Report: TAB REPORT
Function: Test, Adjust, & Balance
Date: 08/19/2025
Completed By: National TAB

PROJECT
08-18-25 CAVA BURLINGTON, MA

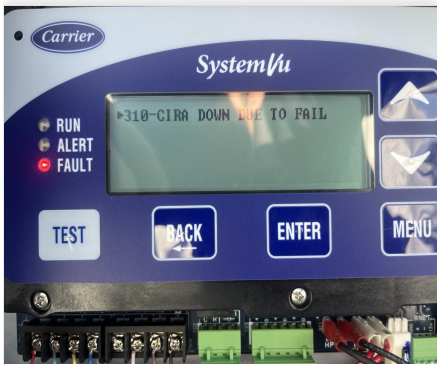
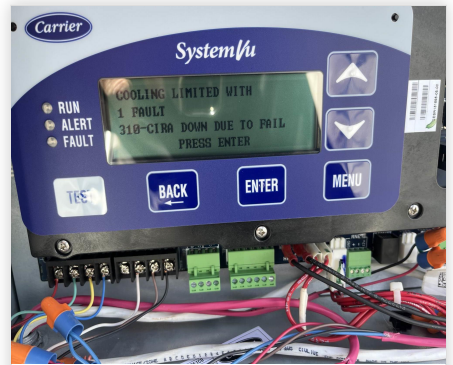
Issue Name : RTU-1 (KITCHEN): Cooling is not Functional
Description : Cooling is locked out on RTU-1 serving the kitchen. Suspect low pressure alarm. Unit needs service.
Created By : National TAB **Assigned To :** National TAB - Michael McDonnell
Status : Open
Priority : High **Asset Tag :**
Originated Date : 08/19/2025 - Michael McDonnell - National TAB

- **08/19/2025 National TAB - Michael McDonnell**
 - Gas valve at this unit in off position. Suggests unit has not been started up. Could not test heat.

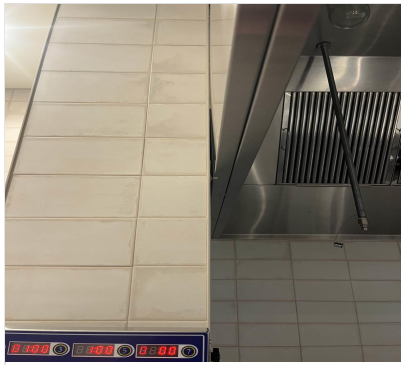
Kitchen Hoods are flush against the wall along the bottom and each of it's side walls.	Fail
--	------

Gap on left side of wall. Will allow for accumulation of grease and dirt. Recommend this is sealed.

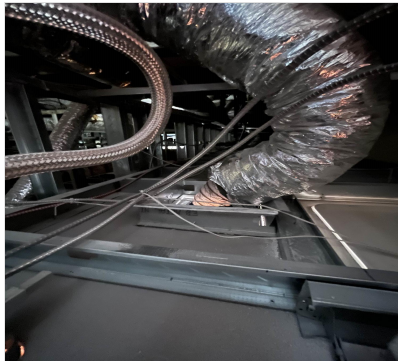
Duct seams are sealed air tight using proper sealant and application for SMACNA pressure rating of duct systems
